THE ROYAL GOLF CLUB AT LAKE ELMO LAKE FLMO MINNESOTA

Royal Golf Club Preliminary Plat/Plans

Cc: Emily Becker, City Planner From: Jack Griffin, P.E., City Engineer Re: Royal Golf Club at Lake Elmo PUD
Preliminary Plan Engineering Review

City of Lake Elmo Planning Department **PUD Concept Plan Review**

Figure 1
City of Lake Elmo
New Development Low Pressure Zone

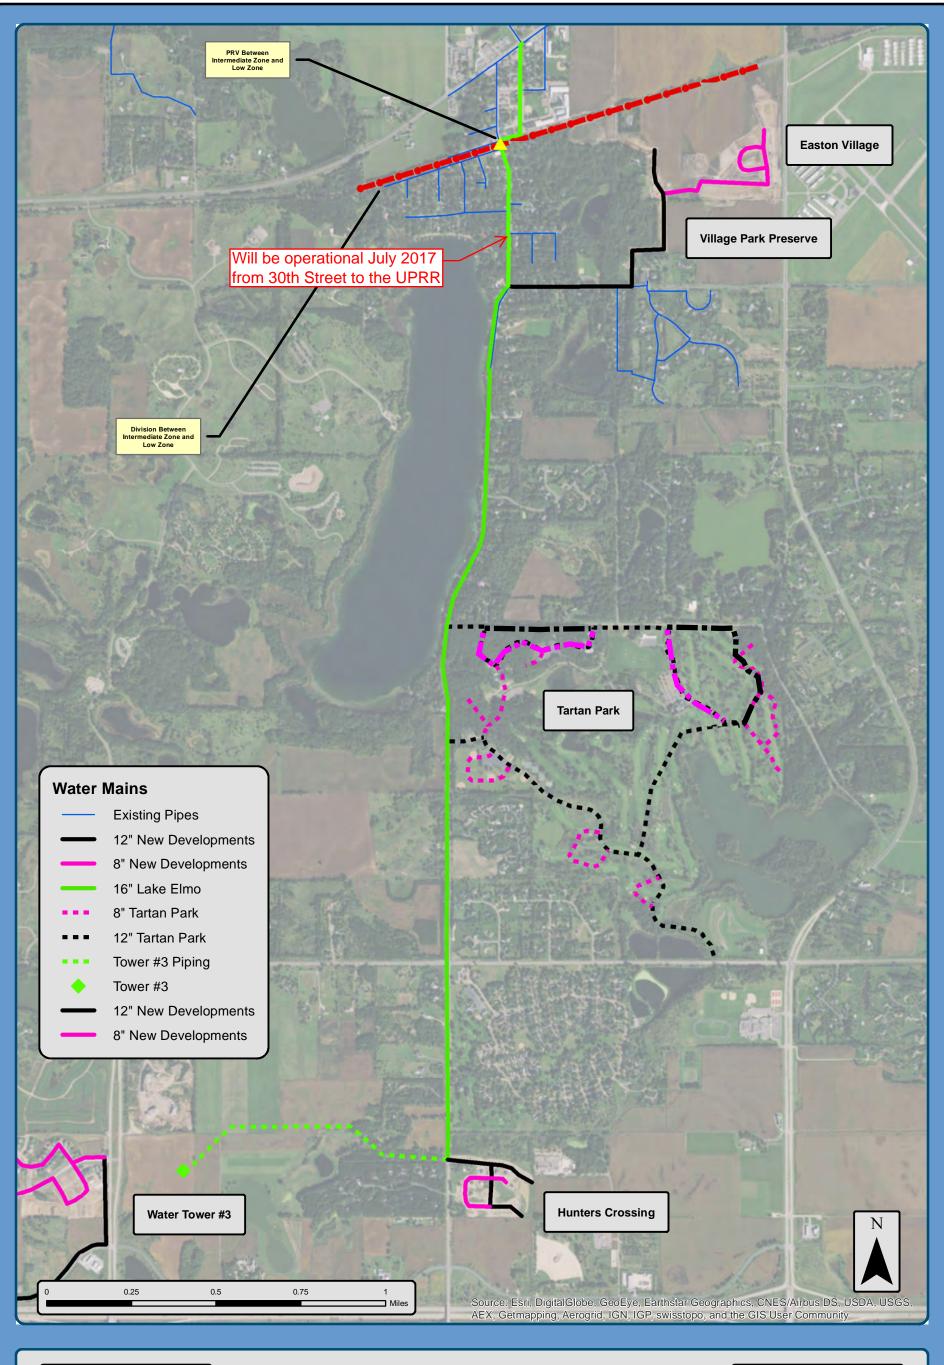
- The watermain distribution network and pipe sizing for this development should be constructed as shown in Figure 1 of the AE2S water system study. This watermain network, including pipe sizes and looping connections, has been correctly shown in the Preliminary Plans dated February 28, 2017.
